**ENGINEERING, OPERATIONS AND PLANNING COMMITTEE MEETING
AGENDA**

TUESDAY, NOVEMBER 21, 2023 - 5:30 PM

1. Updates to the Engineering, Operations and Planning Committee
2. Agreement with San Bernardino County for a Permanent Emergency Interconnection at Glen Helen. **Pg 3**
3. Ion Exchange Resin Replacement at Well 42. **Pg 11**
4. Right of Entry during Construction and License for Pipeline Location with IDIL West Valley Logistics Center, LP. **Pg 40**
5. Reimbursement Agreement for R2-3 Reservoir Facilities Improvements with IDIL West Valley Logistics Center, LP.. **Pg 53**
6. Post Waterline Break Street Repairs. **Pg 86**
7. Oliver P. Roemer Water Filtration Facility Filter Media Replacement and Coating Project. **Pg 92**
8. CHANGE ORDER NO. 3 WITH PCL CONSTRUCTION, INC. FOR THE OLIVER P. ROEMER WATER FILTRATION FACILITY UPGRADE AND EXPANSION PROJECT. **Pg 130**

Revision: **Sheet: 94 of 293**
 Drawing No.: **S-101**

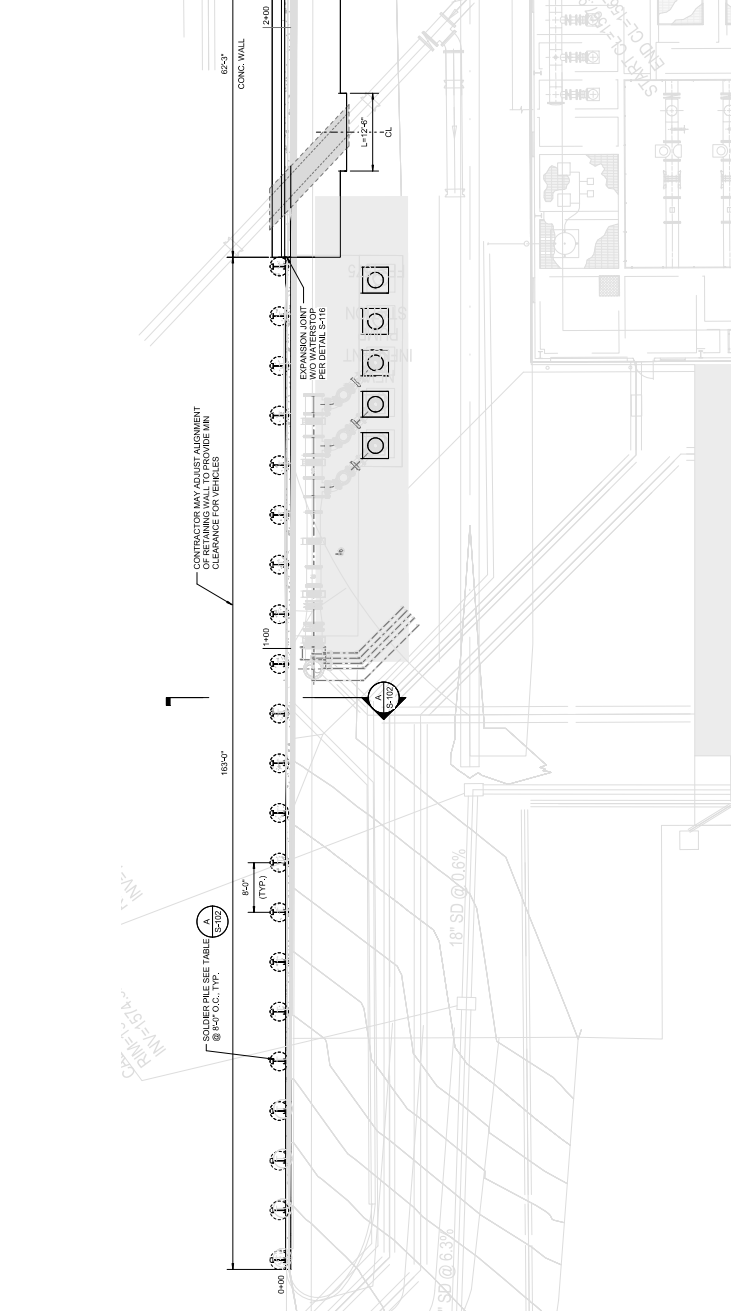
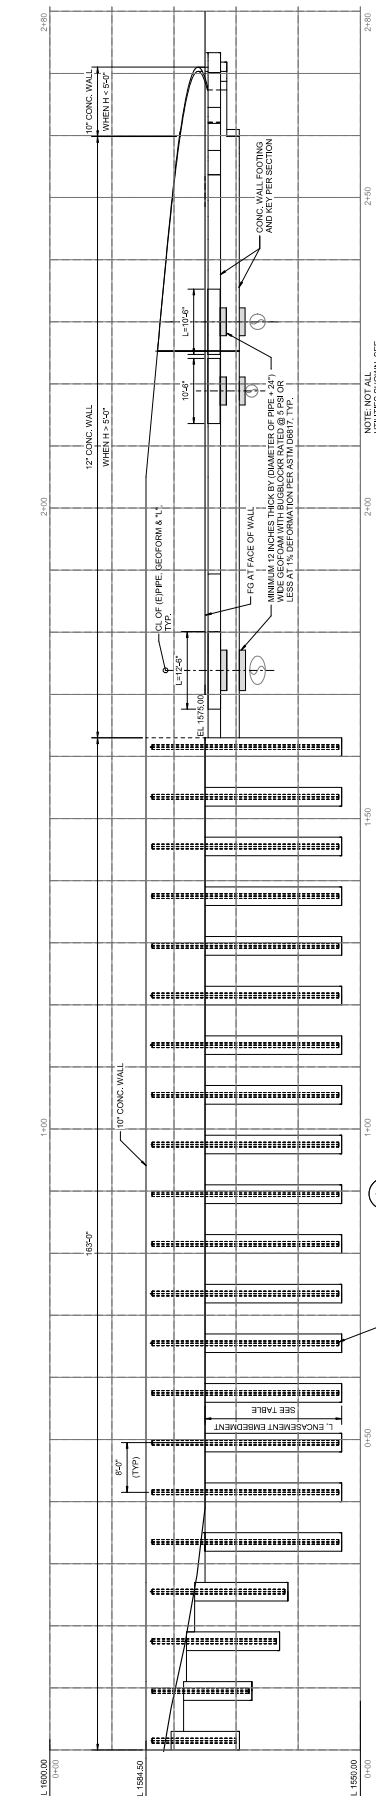
The 1-0 pop out extensions at retaining wall footing make up roughly \$560 of our CO #04. They add 273#'s a couple of Man Hours and 1 hour detailing.

Title: **EFFLUENT PUMP STATION SECTIONS AND DETAILS**
 Revision: **Sheet: 110 of 293**
 Drawing No.: **S-402**

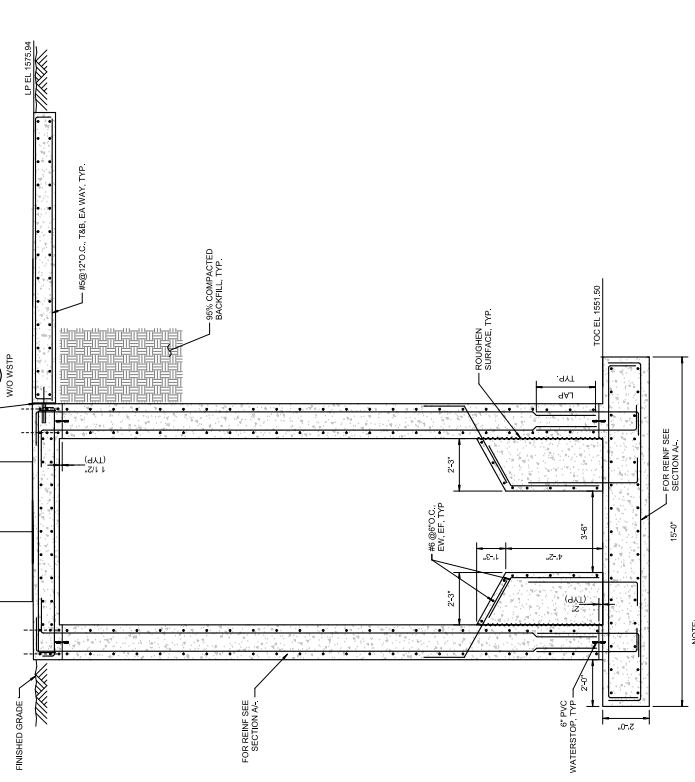
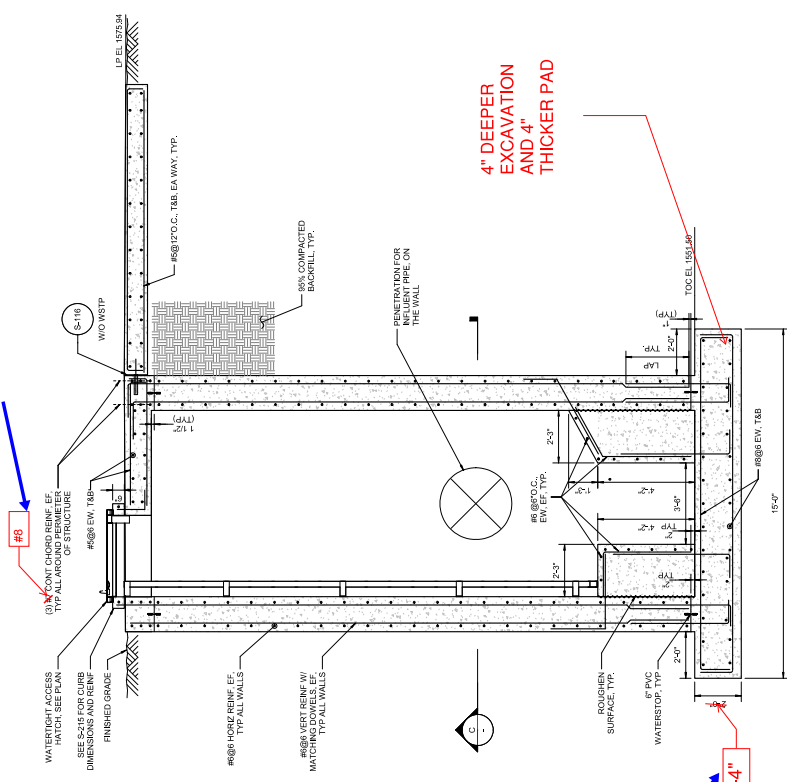
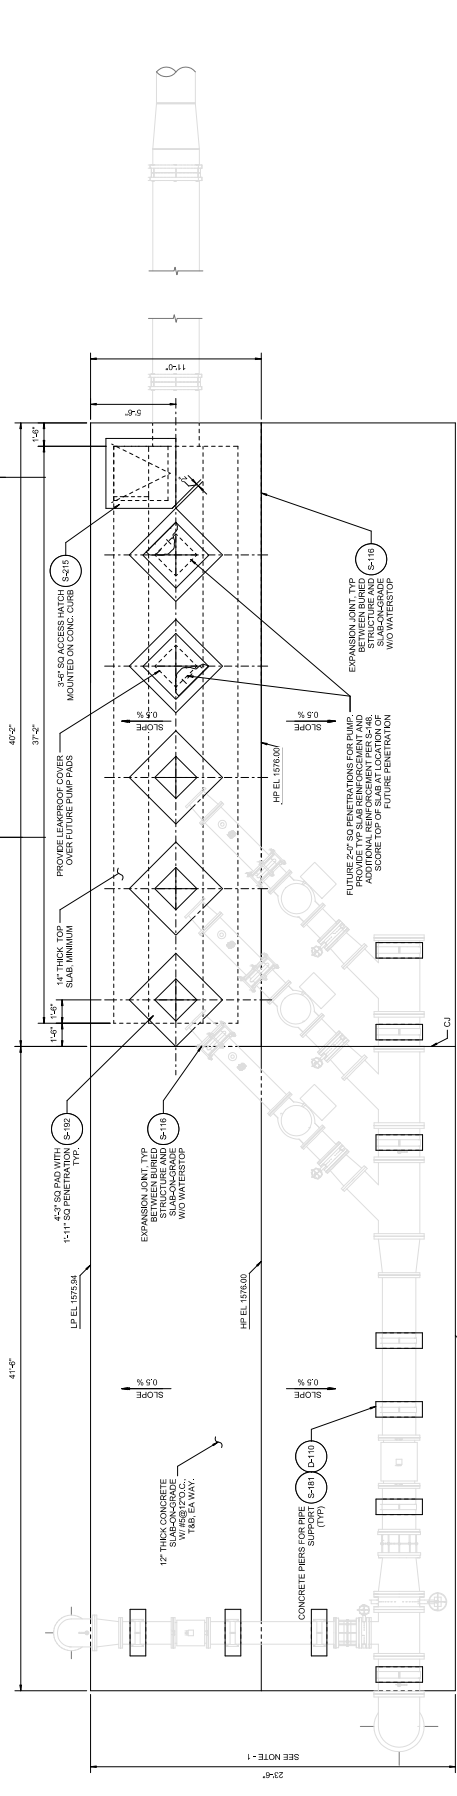
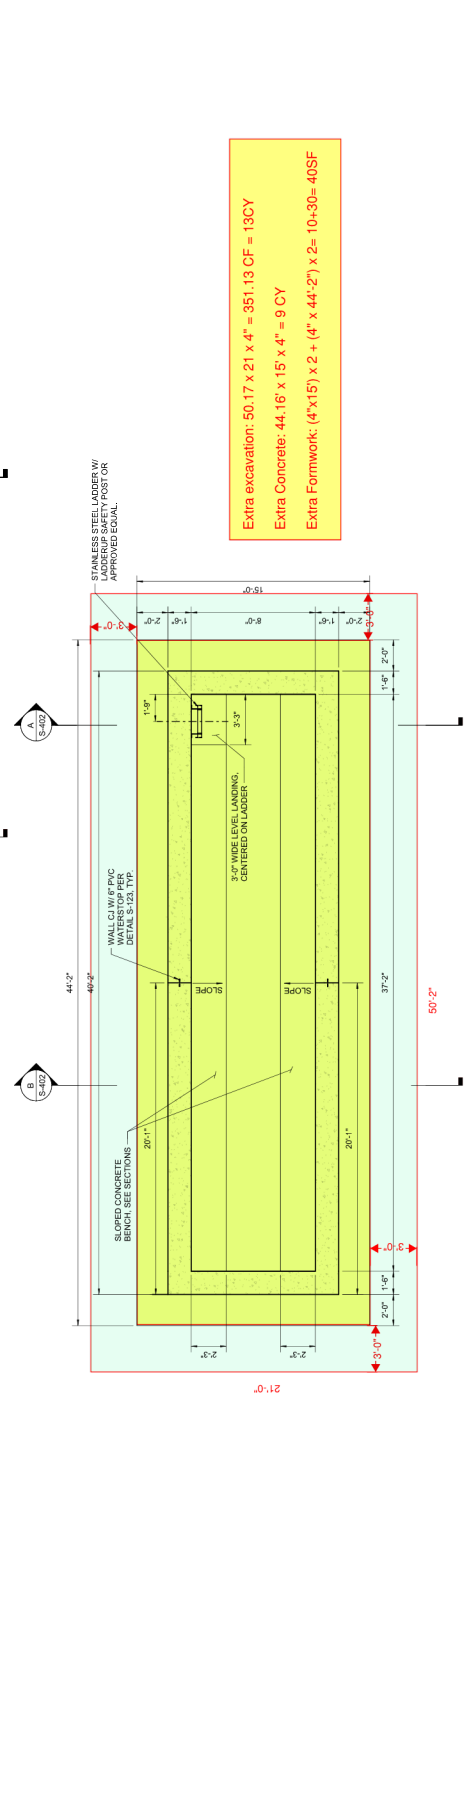
4" DEEPER EXCAVATION AND 4" THICKER PAD

Extra excavation: $50.17 \times 21 \times 4' = 351.13 \text{ CF} = 13 \text{ CY}$
 Extra Concrete: $44.16 \times 15 \times 4' = 9 \text{ CY}$
 Extra Formwork: $(4' \times 15') \times 2 + (4' \times 44'-2'') \times 2 = 10+30 = 40 \text{ SF}$

60% Drawings

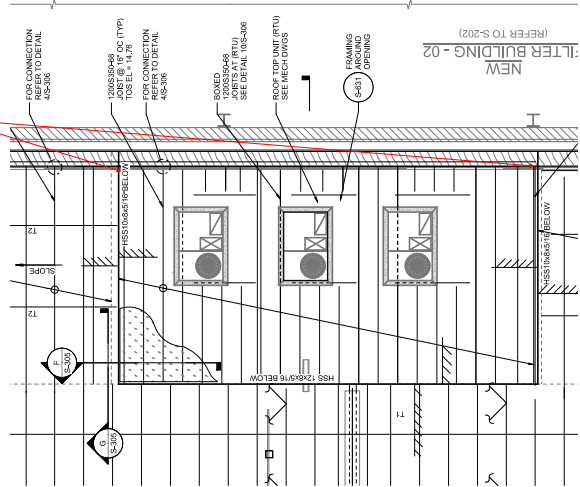
It was assumed the connection for the HSS 10x35x16 Beam would be similar to this detail

Early sets of drawings didn't have a connection Detail for this beam, and during the time our sub bid the supply and install, it was assumed that the connection would be similar to the framing joist connection above.

90% Drawings

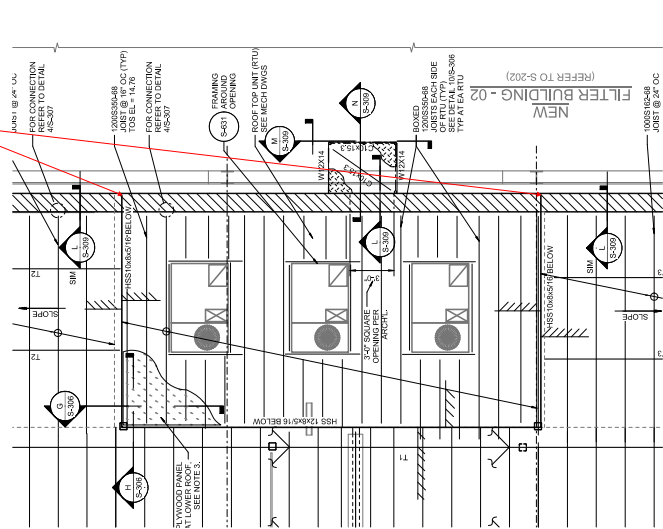
It was assumed the connection for the HSS 10x35x16 Beam would be similar to this detail

The 90% drawings still didn't have a connection Detail for this beam, and we still assumed the connection would be similar to the framing joist connection above.

100% Drawings

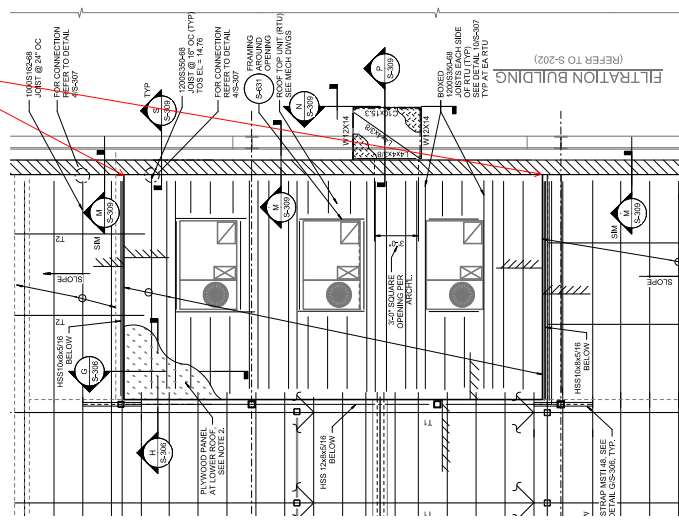
New Detail not in previous drawings prior to risk category. Steel for the base plate and more anchors than what was assumed for this location.

The 100% drawings provided a connection Detail for this beam, and there was an increase in the anchors needed for the mounting plate and in the overall size of the plate to accommodate the anchors based on the changes in risk level. This was confirmed with Simon at Stantec.
